**DRAFT PACIFIC FISHERY MANAGEMENT COUNCIL (COUNCIL) COMMENT
LETTER ON DRAFT OREGON WIND ENERGY AREAS**

Re: Bureau of Ocean Energy Management Request for Comments: *Draft Wind Energy Areas - Commercial Leasing for Wind Power Development on the Oregon Outer Continental Shelf (OCS)*

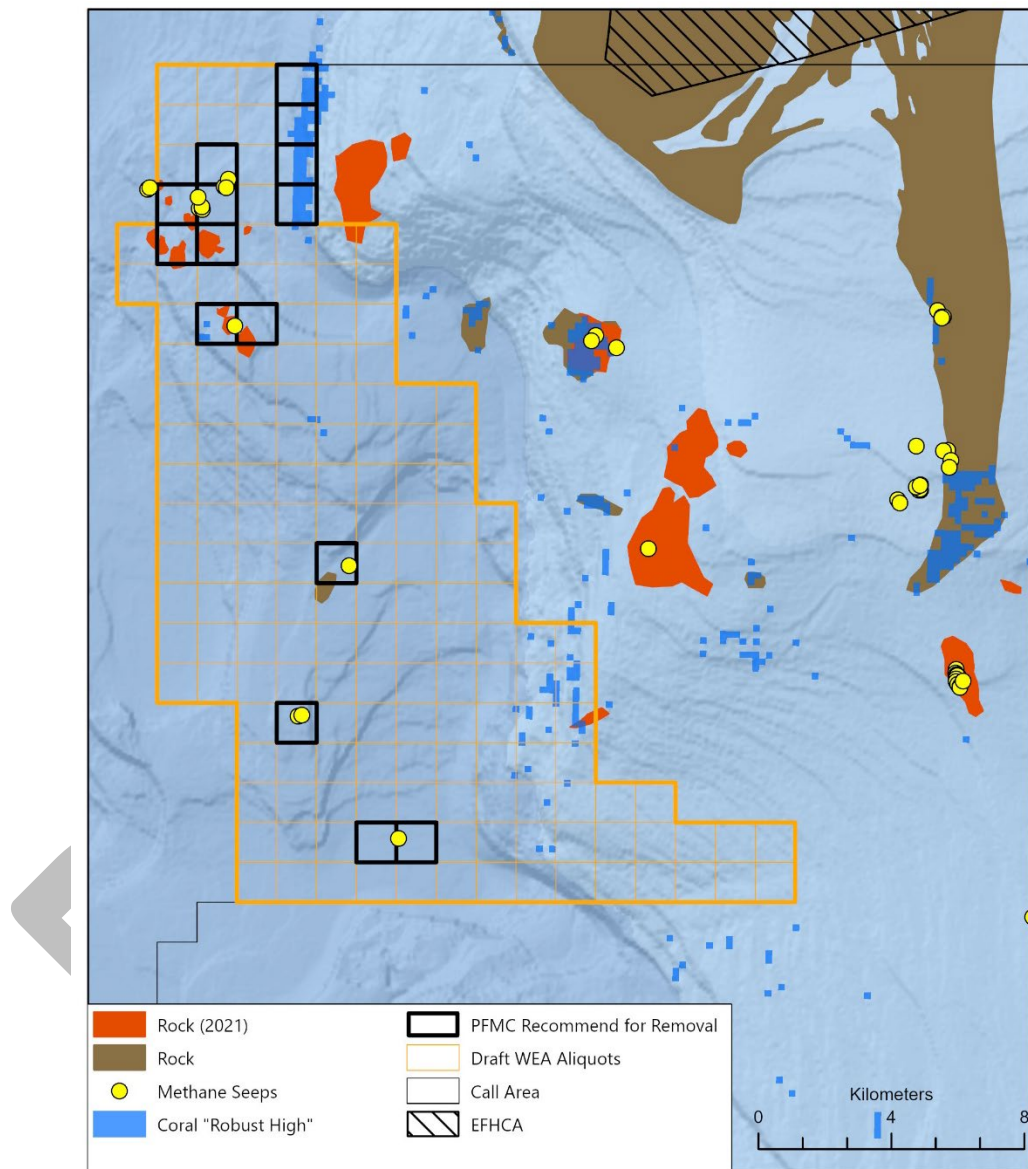
Significant benthic habitat resources are concentrated in the northern region of Draft WEA A (Figure 20). Aliquots **NK10-01/ 6018F, 6018I, 6018J, 6018M, 6018N** overlap several carbonate rock outcrops totaling 5 sq km (identified by Merle et al., 2021) which coincide with methane seep bubble streams that support one of the most diverse seep faunal communities discovered during NOAA's Nautilus Research Dives NA072 and NA095 (Embley 2016, Wilkinson 2018). The northeast boundary of Draft WEA A overlaps areas of "robust high" habitat suitability for coral taxa (modeled by Poti et al. 2020). Adjacent to the coral is a massive carbonate rock structure just outside the Draft WEA, further precluding any path for possible cable routes. A significant portion of the WEA's eastern boundary either overlaps or is in proximity to the shelf break. The shelf break is a region of important ecological processes, such as upwelling, which fuels ocean productivity (e.g., krill) and food web dynamics, and where species tend to concentrate. The habitat resources

The Council recommends avoiding areas with sensitive benthic habitat resources by removing aliquots within Draft WEA A that have substantial overlap with these resources (as shown in Figure 20 and Table 2). The Council recommends implementing a minimum 500 m buffer around these resources to prevent disturbance or damage from site assessment, installation and operations activities associated with wind projects and cable routes.

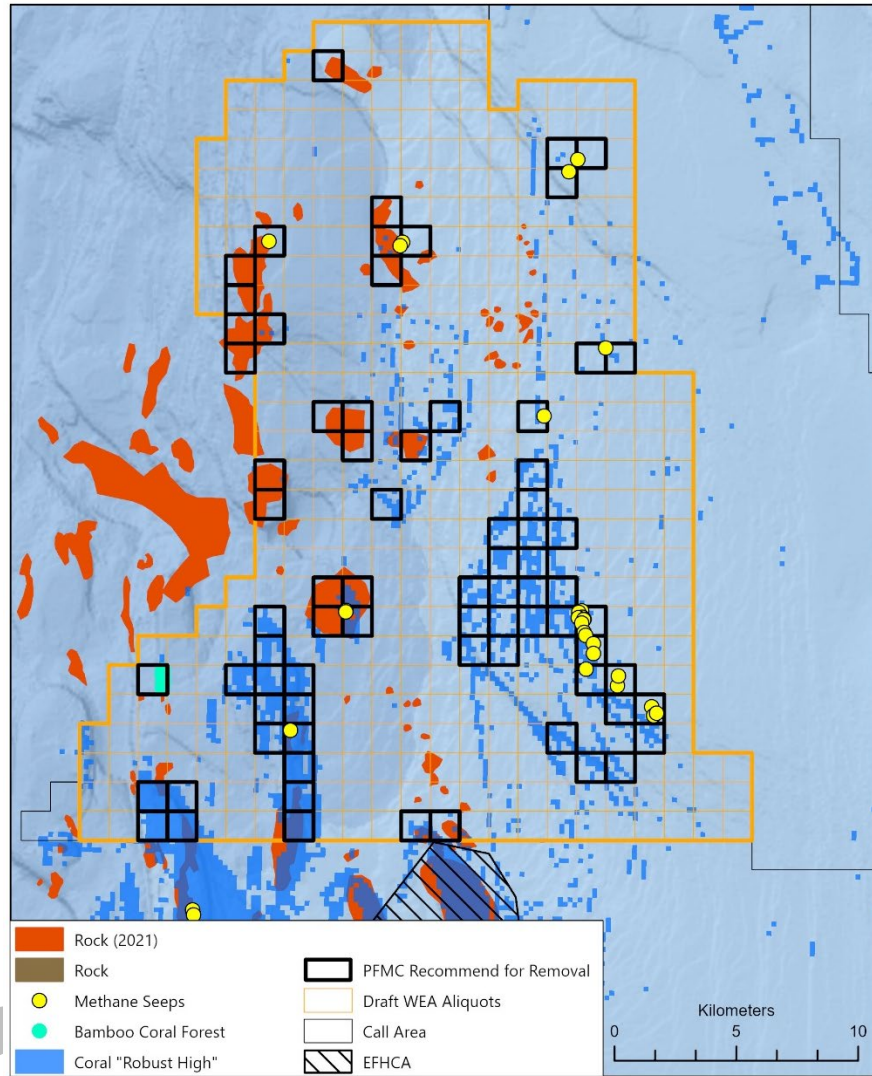
Significant sensitive habitat resources occur throughout Draft WEA B (Figure 21). There is 55 sq. km. of carbonate rock in Draft WEA B throughout the USCMMB coverage area (investigated by Merle et al. (2021). Where the USCMMB data coverage ends (somewhat near the 750 m or 800 m isobath), there may be additional backscatter data collected by USGS that could indicate additional rock in the eastern portion of Draft WEA B (Susan Merle, personal communication). As noted above, we recommend BOEM expedite efforts to identify rock habitat in the USGS backscatter data and other recent backscatter data in areas associated with offshore wind development.

The Council recommends avoiding areas with sensitive benthic habitat resources by removing aliquots from within Draft WEA B that have substantial overlap with these resources as shown in Figure 21 and Table 2. The Council recommends implementing a

Figure 22: Probable rock (blue oval) on Heceta Bank's south flank discernable in high-resolution multibeam data (source: MBARI 1998). Backscatter imagery (USCMMB) used to identify hard substrate (red outline) by Merle et al. (2021) not available for this figure. USCMMB footprint shown in yellow.

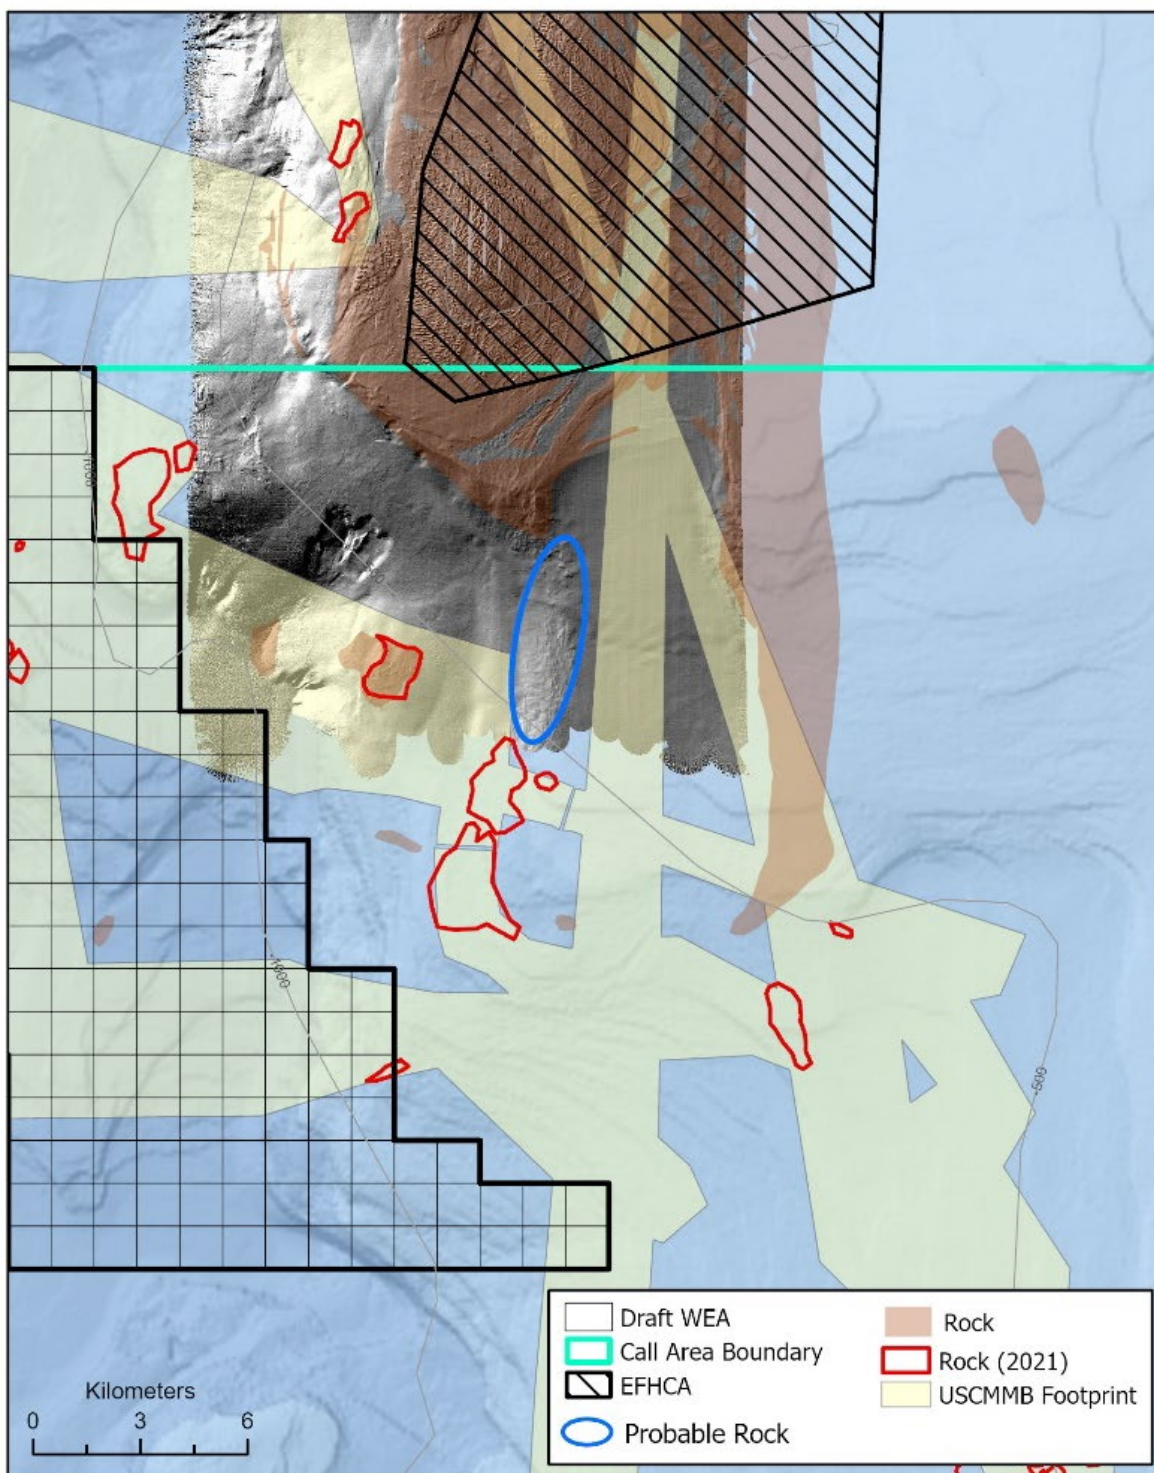
Most of Heceta Bank was mapped with high (10m) resolution multibeam bathymetry sonar (MBARI 1998) and is well-characterized. The top of the bank is predominantly rock ridge and boulder-cobble fields surrounded on the western and southern margins by unconsolidated sediments. The multibeam coverage of the southern flank extends southward 10 km into the Coos Bay Call Area (Figure 22). A review of the backscatter data on the southern flank confirms that a significant portion of this extension is accurately delineated as rock (boulder/cobble). Upon close examination, the multibeam backscatter data indicates an area of rock outcrop that was classified as unconsolidated sediment but appears to be hard substrate. The rock feature is located at 124.876°W between 43.91°N and 43.862° N) and extends 6 km to the south from the current delineated rock polygon. This extension of rock connects to the rock delineated by Merle et al. (2021) resulting in a continuous band of rock as far south as 43.81° N and precludes cables routes exiting the northern two thirds of Draft WEA A from being routed directly eastward. Additionally, the “leg-shaped” feature along the eastern margin of the bank is classified as rock. The portion of this feature that is west of 124.79° W is within the Monterey Bay Aquarium Research Institute (MBARI) multibeam footprint and the interpreted rock is consistent with the backscatter imagery. There is additional rock at the edge of the backscatter imagery, east of 124.79°. Additional mapping is necessary to characterize the seafloor east of 124.79° W before cable routes are considered through this area.

The Council recommends avoiding Heceta Bank entirely by implementing a minimum 500 m buffer around the Heceta Bank complex, including the western and southern flanks to encompass the additional 16 km southern extension of rocky reef HAPC discussed above.
